ECE/TRANS/WP.29/GRE/2006/44
21 July 2006

PROPOSAL FOR DRAFT AMENDMENTS TO REGULATION No. 112

(Headlamps emitting an asymmetrical passing beam)

Submitted by the expert from the Working Party "Brussels 1952" (GTB)

"Annex 4 - Appendix 1

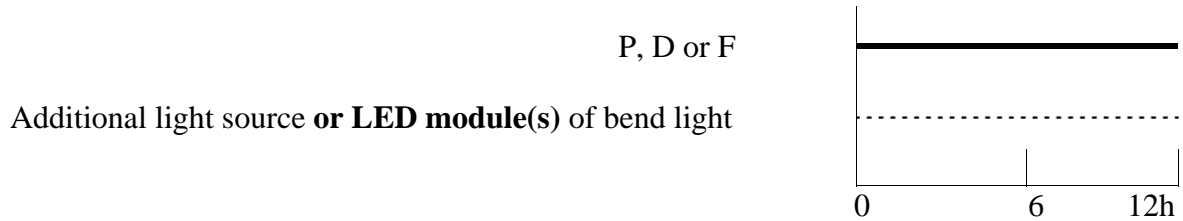
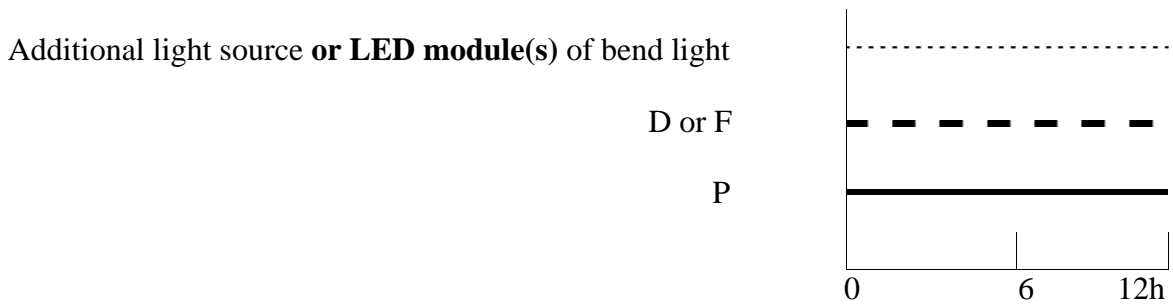
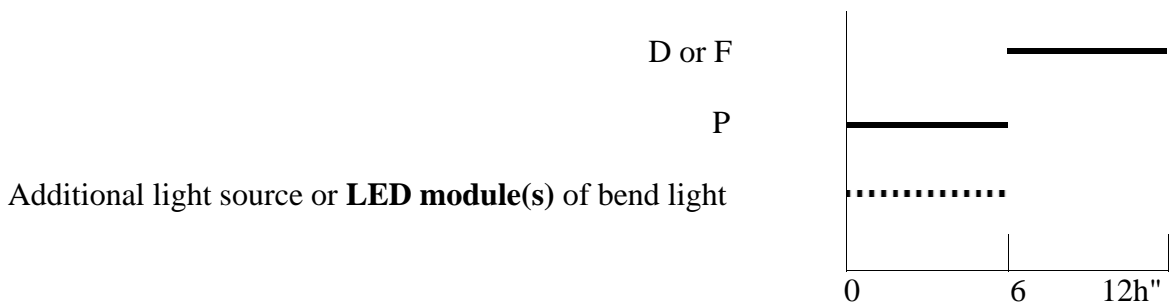
Annex 4 - Appendix 1, amend to read:

OVERVIEW OF OPERATIONAL PERIODS
CONCERNING TEST FOR STABILITY OF PHOTOMETRIC PERFORMANCE

Abbreviations: P: passing beam lamp
D: driving beam lamp (D₁ + D₂ means two driving beams)
F: front fog lamp
- - - - means a cycle of 15 minutes off and 5 minutes lit
..... means a cycle of 9 minutes off and 1 minutes lit
